REBUTTAL REPORT: PART 1

**REVIEW OF EVIDENCE REPORTS SUBMITTED BY SOUTHERN NEVADA WATER AUTHORITY IN SUPPORT
OF WATER RIGHTS APPLICATIONS FOR SPRING, CAVE, DRY LAKE, AND DELAMER VALLEYS**

Presented to the Office of the Nevada State Engineer

On behalf of Great Basin Water Network and the Confederated Tribes of the Goshute Reservation

Figure 1: Snapshot of Figure E-1 (Burns and Drici, 2011) showing SNWA's perceived interbasin flow to or from the WRFS.

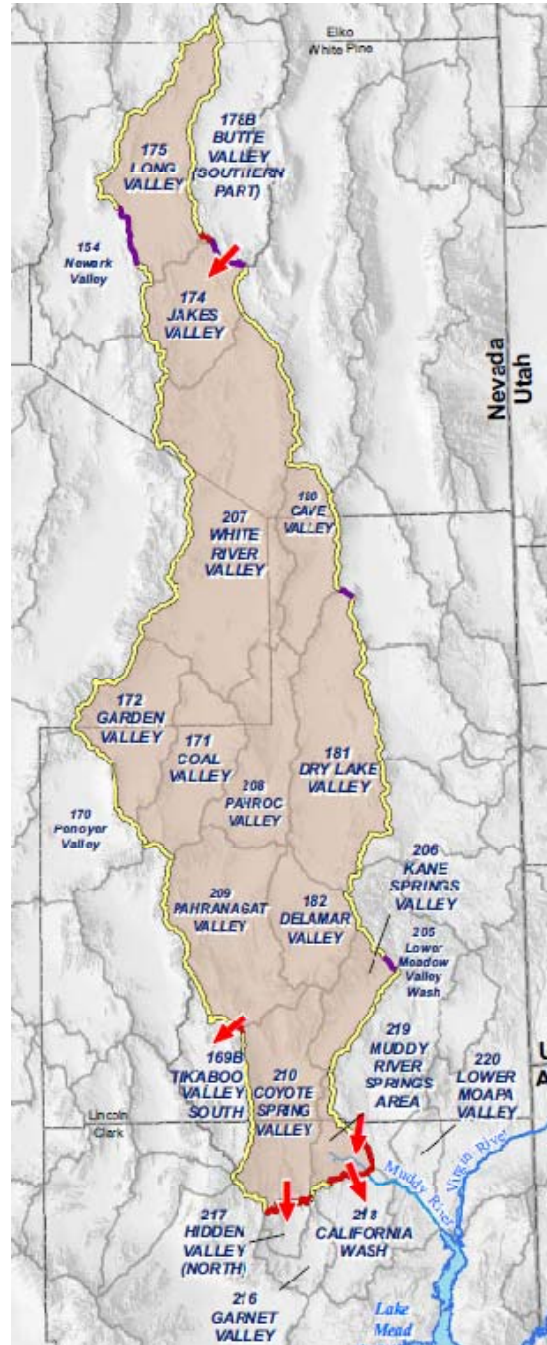
The remainder of this section reviews the components of the water balance calculation: GWET and interbasin flow. Because of the overlap, I consider the WRFS and Spring Valley jointly. The WRFS includes a north-south trend of basins commencing with Long and Steptoe Valleys in the north and culminating with Lower Moapa Valley and California Wash in the south. Figure 1 shows SNWA’s perception of the WRFS, including the interbasin flow which will be considered below. Importantly, it does not include Steptoe Valley because they reject the concept of interbasin flow from that valley to the WRFS.

Figure 3: Snapshot from Rowley et al (2011), Plate 1, showing their geology in the Egan Range and other areas near Ely.

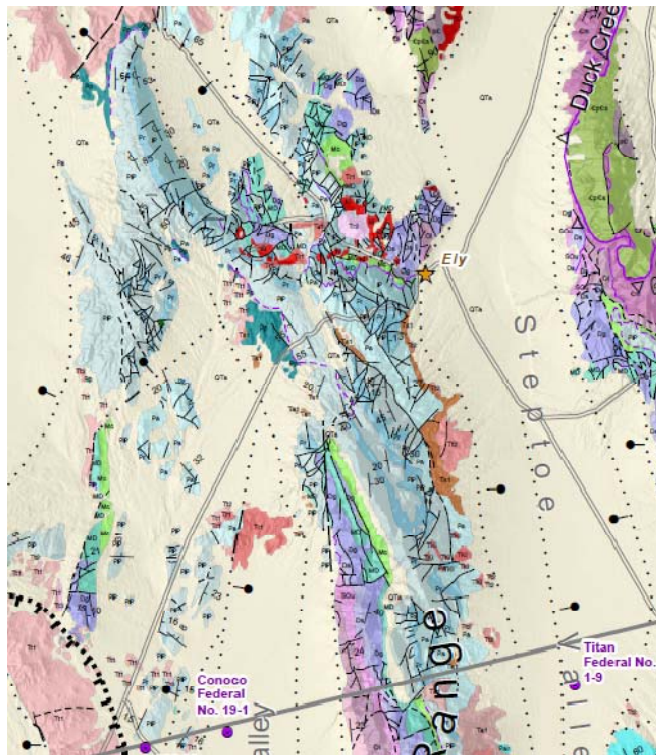
SNWA argues there is no flow from Steptoe Valley to any adjacent valley, based on strident geologic arguments (Rowley et al, 2011, ps. 6-6, 6-7, 6-11, and 6-12). The arguments are based mostly on the presence of faults or high elevations over the pass, and simply do not have any hydrologic data to support them. For example, Figure 3 shows significant Riepe Spring and Ely Limestone in the Egan Range south of Ely and significant faults, but they present no hydrologic evidence that no flow occurs.

Figure 4: Snapshot from DEIS Figure 3.2-5 (BLM, 2011) showing drawdown in Spring, Lake, Steptoe, and Cave Valleys.

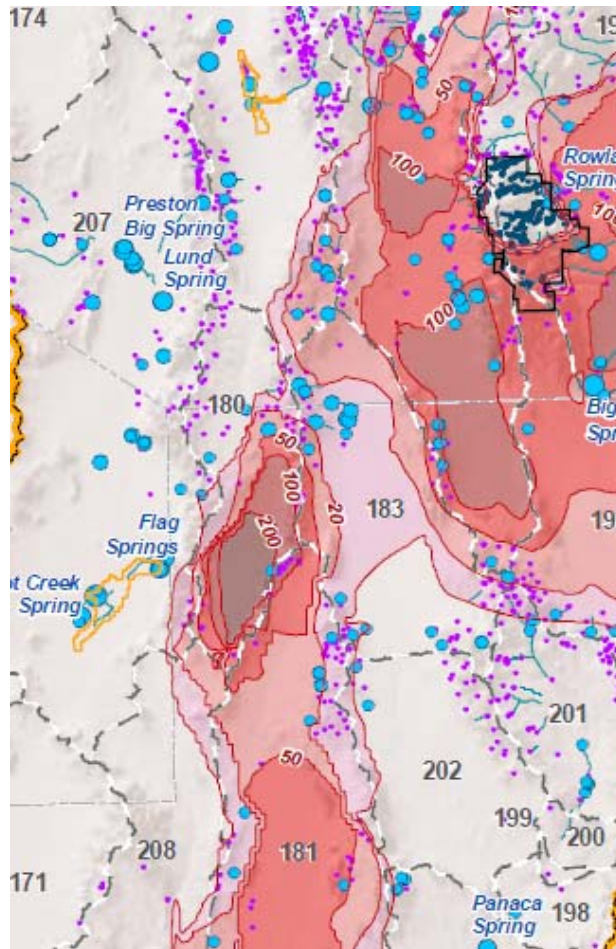
Finally, SNWA’s groundwater model as used in BLM (2011) demonstrates that flow can occur between Steptoe and Spring Valley. Figure 3.2-5 (BLM, 2011) shows that up to 50 feet of drawdown occur in the north end of Lake and the southeast portion of Steptoe Valley (Figure 4). This can only occur if and only if the geology coded into the model allows this flow. The baseline data reports for the DEIS model (BLM, 2011) were SNWA (2008 a and b). SNWA (2008b) does not specifically address this interbasin flow. The conceptual model report (SNWA, 2009a) includes the flow only as part of an uncertainty analysis in their flow system water balance model. It seems that SNWA’s reports reject the potential for flow between Steptoe and surrounding valleys, but the model authors found it difficult to code the faults as

substantial enough barriers to truly prevent the flow. BARCAS estimated that 20,000 af/y flows to Lake and 4000 af/y to Spring Valley from Steptoe Valley (Figure 2).

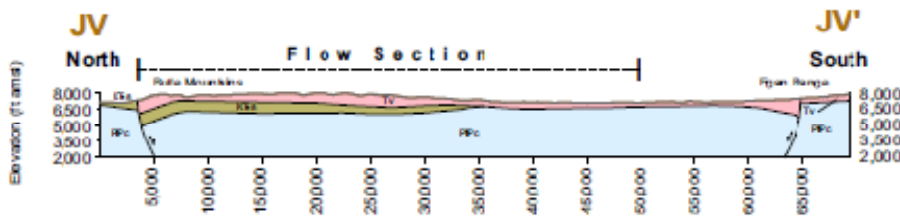
SNWA estimates that 6700 af/y flows from southern Butte to Jakes Valley (Figure 6), whereas BARCAS estimated 16,000 af/y. Interestingly, their map (Burns and Drici, 2011, Figure E-2) shows flow through this section only as “permissible” and also shows several normal faults that are perpendicular to the proposed flow path; they do not explain why these faults do not prevent the flow when in some many other points throughout the study domain normal faults do prevent flow. However, they may have underestimated the interbasin flow in the WRFS by setting the thickness too low. They used a mean K of 6.16 ft/d and two cross-sections, 30,000 by 500 feet and 15,000 by 1500 feet; the thicker section is on the right (Figure 6). Burns and Drici (2011) do not justify their assumed thickness. Their figure shows thickness of up to 4500 feet, which could be thicker yet if the carbonate rock continues lower than the chosen section. Even if their chosen conductivity is too high (a mean K may not apply to bulk carbonate rock), the additional thickness applied to the section suggests the cross-sectional flow could be much higher - much closer to the BARCAS value. This is another example of how SNWA’s Darcian flow estimate’s failure to account for surrounding basin water budgets leads it to significantly underestimate inflow to the WRFS.

Figure 7: Snapshot from Figure E-4 (Burns and Drici, 2011) showing Muddy River springs and the fault that controls the springs. The map also shows the cross-section used by SNWA for estimating flow from MRSA to California Wash.

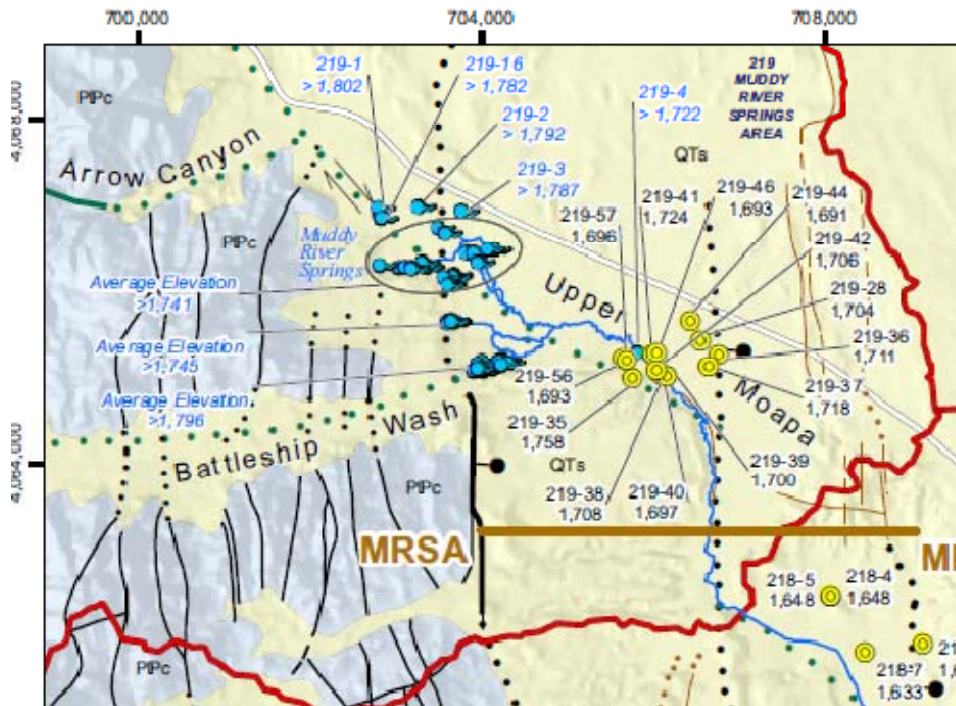
SNWA estimates flow across the cross-section in Figure 7 to be 9900 af/y, but as noted based on the faults controlling the springs, there is likely little flow from upstream in the WRFS to this section. SNWA estimates that 8000 af/y enters the MRSA from the Lower Meadow Valley Wash; they base their estimate on other studies. Based on the location to the east side of the MRSA and the faults, it is not likely that much of this water discharges from the springs either. For the purpose of the WRFS, it would be appropriate to assume that discharge to California Wash from the MRSA equals the flow from the Lower Meadow Valley Wash, and not include it in further water balance calculations.

Figure 8: Snapshot from Figure E-3 (Burns and Drici, 2011) showing the perceived flow path from Coyote Spring to Hidden Valley.

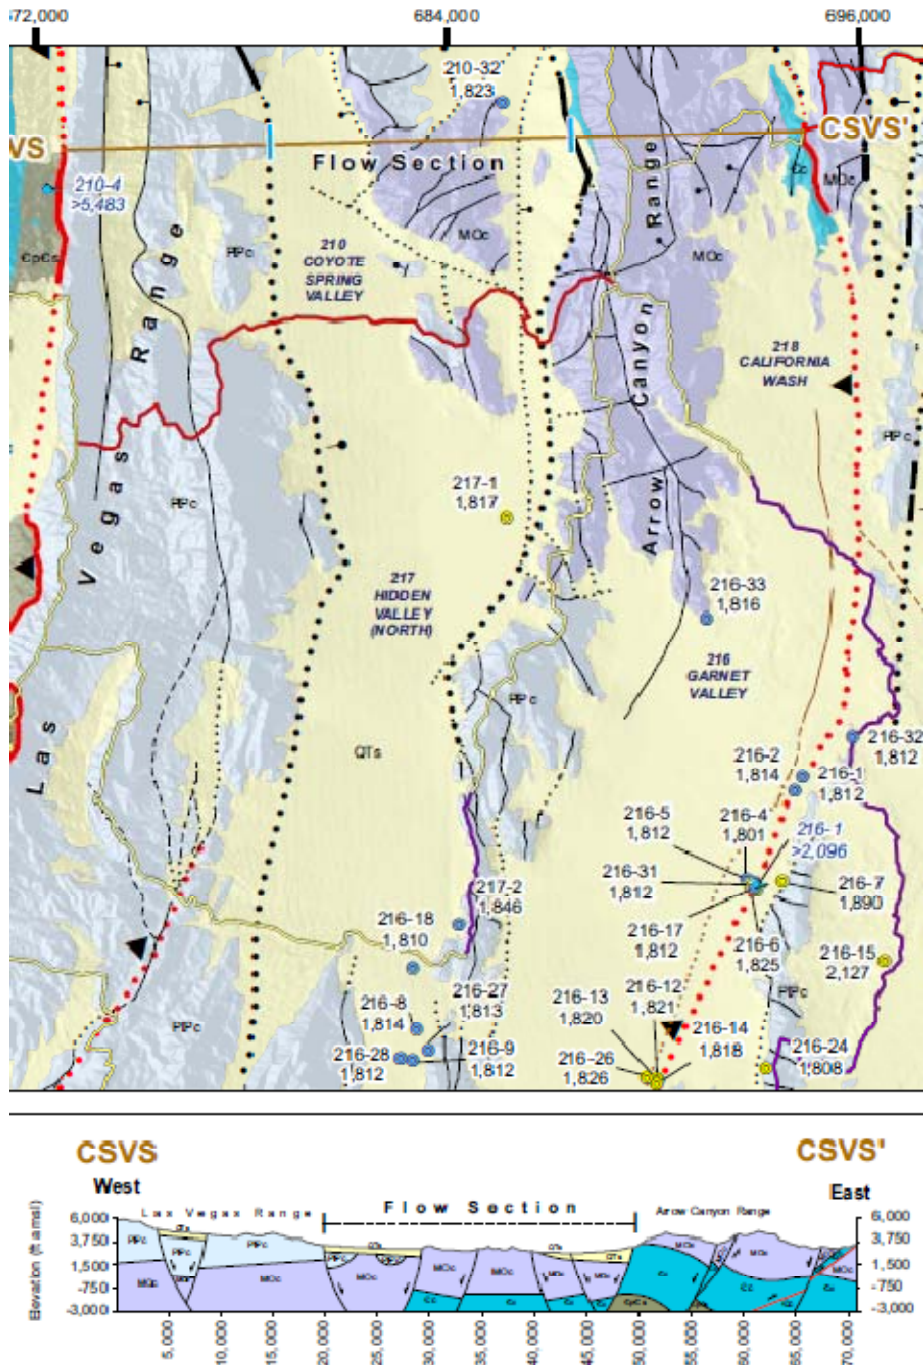
The gradient from Coyote Springs to Hidden Valley is essentially flat), with a six foot drop from well 210-32 to 217-1, over about eight miles (Figure 8). SNWA estimated flow between these valleys using Darcy’s law with a geometric mean transmissivity of approximately 213,000 ft²/d and a 30,000-foot width and a gradient determined between wells CSVM-2 (210-32) and GV-1 (216-18)(Figure 8). The extremely low gradient and high transmissivity are both potential errors in this calculation. Over this long distance, it is a large assumption that the flow paths are connected so that the gradient accurately depicts the real situation. Intermediate water levels could be significantly higher so that a smaller gradient or even a divide is reality; a few feet could make the difference. SNWA uses an average transmissivity from the tabulated pump tests (Table E-1, Burns and Drici, 2011). SNWA claims these are representative because they only used long-term tests. Several of the wells on that table are known high producers. SNWA likely represents wells in significant fracture zones which would have a high conductivity. It should be noted that the section (Figure 8) spans a carbonate outcrop several miles into Coyote Spring Valley, again near the high producing wells. There is no evidence this section is representative for flow between the valleys.

Although it is impossible to rule out any flow, based on the extremely low gradient and fracture-based transmissivity of fracture systems, the flow would be much closer to zero. The deuterium measurements provided do not indicate a flow but merely indicate the groundwater in the carbonate rock in Coyote Spring and Garnet Valley could have a similar source.

Figure 9: Snapshot of portion of Burns and Drici (2011) Figure B-2, Locations and Data Sources for Precipitation Stations Located in Area of Interest.

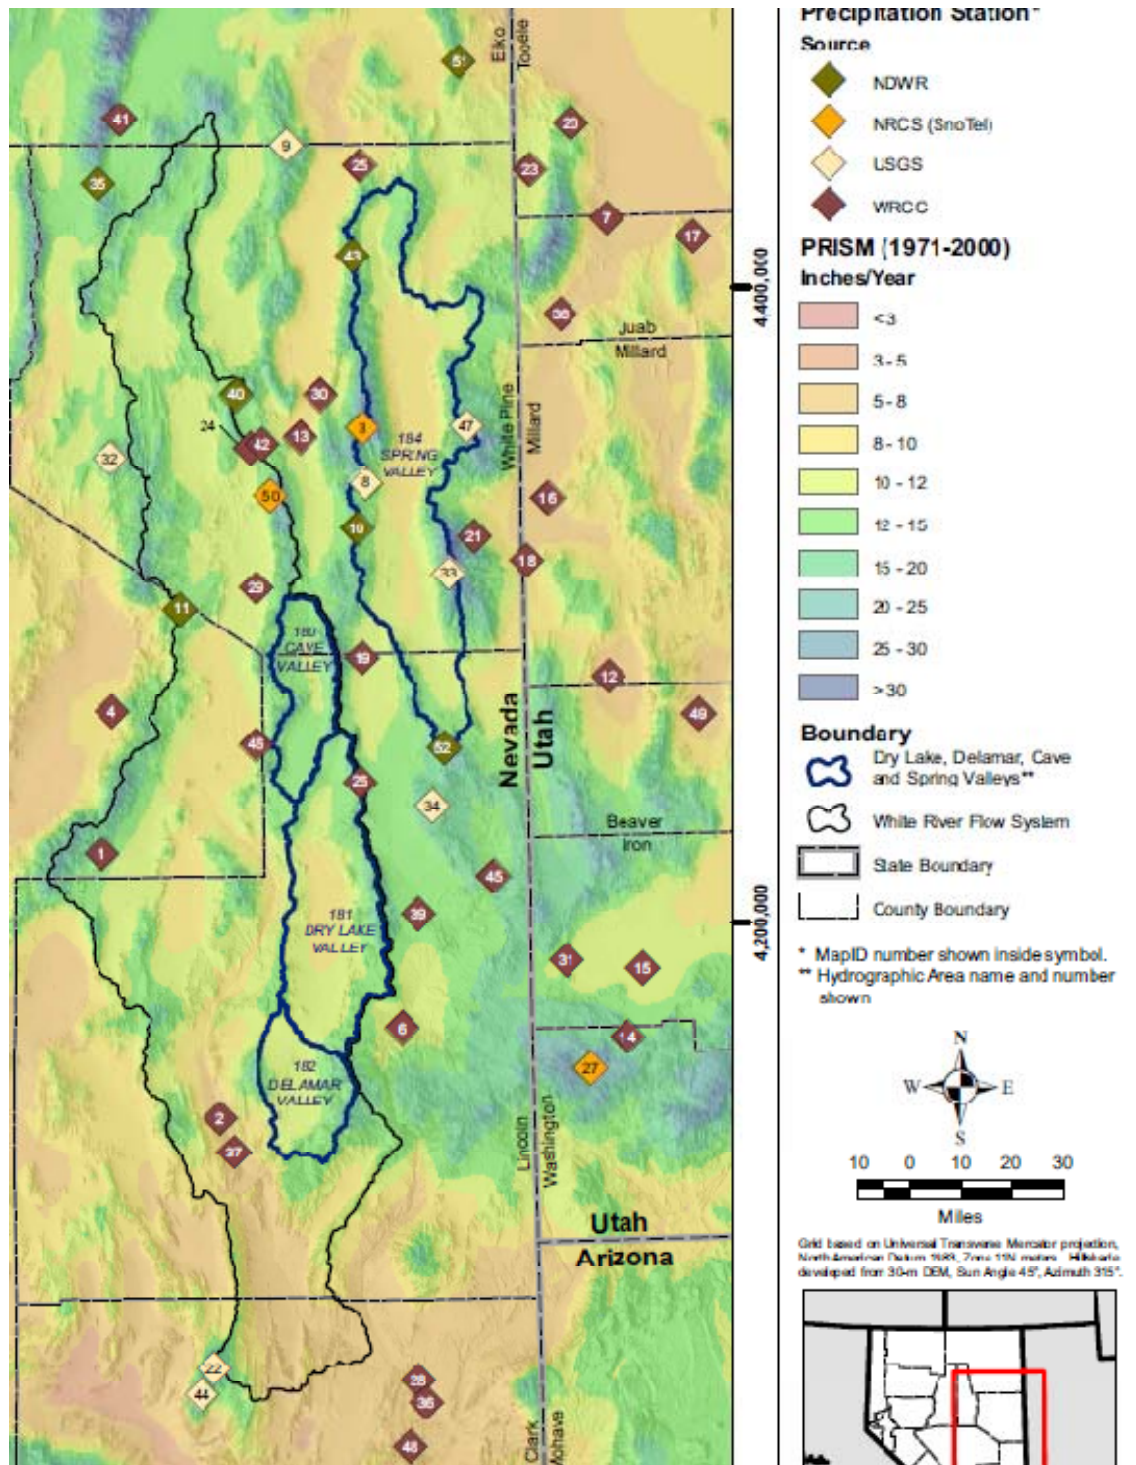
The distribution of annual precipitation determined with PRISM and the precipitation stations used by SNWA to compare with PRISM estimates is shown on Figure 9. The major problem with this distribution is the band of high precipitation that is evident, mostly in lower elevations, from southern Cave Valley through Lake and Patterson Valley to southern Hamlin Valley. This band of higher precipitation in the valleys ranges from 12 to 15 in/y. Southern Cave Valley is in this band even though it is 1000 feet or more lower than the valley in the northern part. The low divide between Patterson and Lake Valley is less than 6000 feet, but precipitation is in the 12 to 15 in/y range (Figure 9). PRISM has a broad extent of Spring Valley, near or slightly lower than 6000 feet, with precipitation ranging from 8 to 10 in/y.

There are few, if any stations within Cave, Dry Lake or Delamar Valleys, and just a few around the rim of Spring Valley (Figure 9).

Figure 10: Snapshot of the Cave Valley portion of Plate 6, Rowley et al (2011). Section R-R' crosses the middle of Cave Valley and the section above it, with labels outside of the snapshot, is U-U'

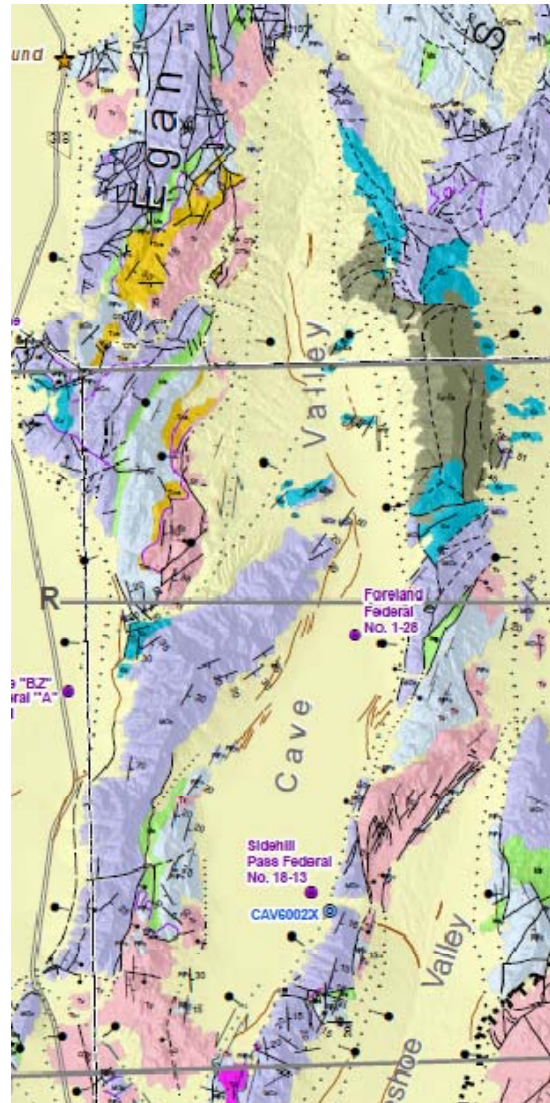
The geology as presented by Rowley et al (2011) does not support the argument and even provides substantive evidence opposing SNWA's view. Figure 10 shows Rowley et al's hydrogeology map for Cave Valley; the carbonate block extending northeast across the valley from the Egan Range is obvious on the map. Cross-section R-R' (Figure 11) shows a section which would support flow along the east side of Cave Valley, but unless the carbonate block is fractured, it would not. Section U-U' (Figure 12) shows a thin fill section underlain by volcanic, carbonate, and clastic rocks. A section through the tip of the carbonate block showing their perception of the section between the block and the Schell Creek Range would have been useful.

Even groundwater from the Schell Creek Range apparently crosses the perceived groundwater flow path to the south, as exemplified by Cave Springs. This spring discharges from carbonate rock about three miles north of the carbonate block (Myers, 2011a, Figure 9). This suggests the carbonate outcrops

shown on Figure 10 and on Myers (2011a) Figure 2 allow groundwater to cross Rowley et al.'s fracture zone flowpath and be diverted southwest toward Shingle Pass (Myers, 2011a; Welch et al, 2008).

Figure 15: Snapshot of Dry Lake Valley and surrounding area isotope values from Thomas and Mihevc (2011), Plate 2. Blue, red, and black circles are cold and warm springs, and representative wells, respectively.

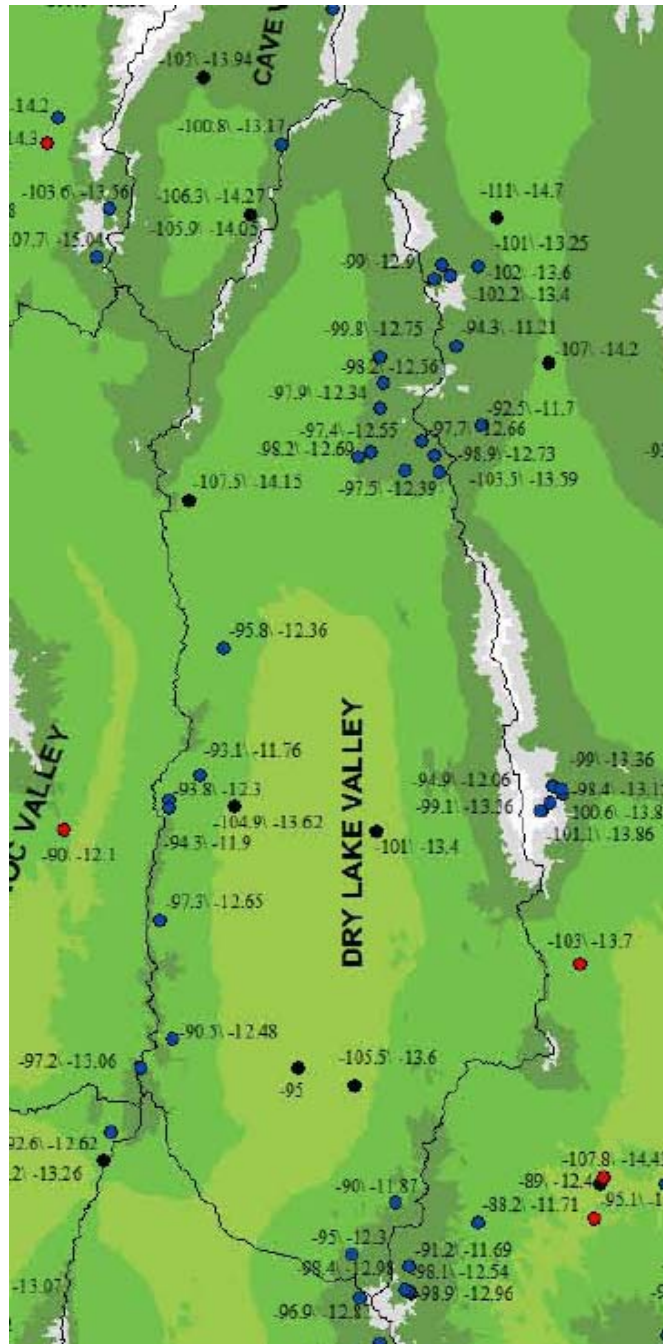
The isotope data in Dry Lake Valley (Figure 15) support the idea that the valley actually has very little recharge. The authors suggest that the well in the northwest portion of the valley with δD equal to -107.5 permil has water from Pahroc or Cave Valley to the west (Thomas and Mihevc, 2011, p. 22). This could be correct, and if so, it suggests there is little mixing of this interbasin flow with local recharge; all springs representing local recharge have δD greater than -100 permil. The authors acknowledge that the two wells in the central portion of the valley having δD equal to -104.9 and -101 permil do not reflect local recharge (*id.*). Of the two wells in the far south of the valley, only the one with δD equal to -

95 permil could reflect local recharge, although its value is actually less negative than most of the recharge observations. The only springs with less negative values are in the far south of the valley which suggests the water in that well reflects recharge in that portion of the valley.

Figure 19: Snapshot of Figure 4-1 from the SNWA Effects report.

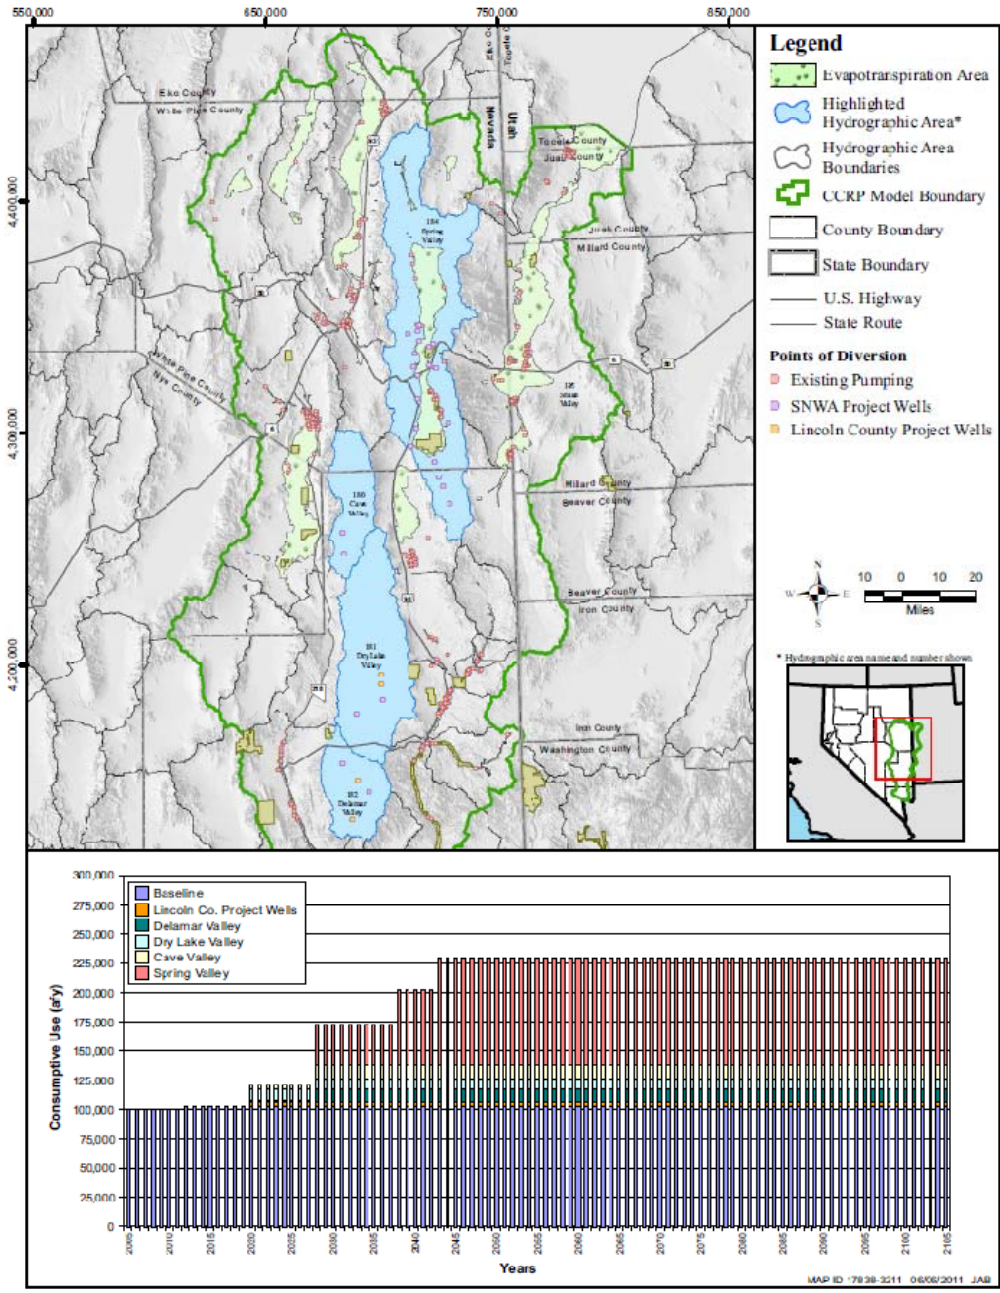
SNWA considered only one potential pumping scenario, as shown in Figure 19. The details of this are that starting in 2019 and 2028, the simulation pumps 14,077 and 34,751 af/y from the Cave, Dry Lake and Delamar Valleys; and in 2028, 2038, and 2042, the simulation pumps 35,000, 64,544, and 91,222 af/y, respectively, from Spring Valley (Table 4-1). Presumably the amount by valley is distributed proportionally among the wells (the report does not state as much). SNWA has not provided the NSE with a full-range of pumping rates or schedules for comparison, as does Myers (2011d).

The report describes the simulation as unrealistic and conservative (p. 4-3). It is anything but – SNWA may pump the full amount from the day the NSE grants the water rights and SNWA constructs the facilities. The ramping schedule analyzed (Figure 19) is not described or justified in the Effects report. There is no justification for considering anything less than pumping the full granted amount from the beginning.
